RL/TW 13070 24 April 2015

DA14/0766 -SECTION 96(2) MODIFICATION LINKS ROAD, DUNHEVED - ST MARYS

Figure 1 – Proposed Modifications to DA14/0766 Source: Cardno – Excerpt from General Arrangement Plan (Drawing Number 89914020-03-S96-1010)

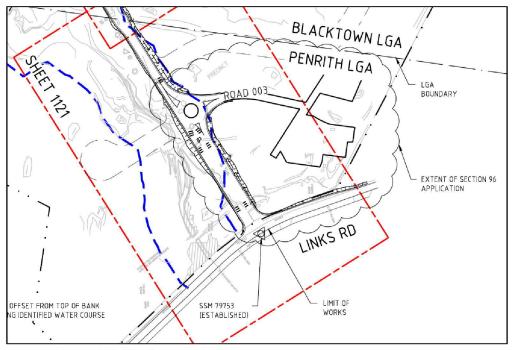
The modifications relate to changes to the Links Road intersection with the haulage road as shown at **Figure 1** including:

- widening of Links Road (into the Dunheved development site) and construction of a 100m right turn bay;
- construction of a roundabout 150m north of the Links Road intersection;
- construction of a holding area for entering trucks to wait adjacent to the roadway at the entrance of the haulage road within the Dunheved Precinct site area; and
- construction of an elevated gate house at the entrance of the haulage road.
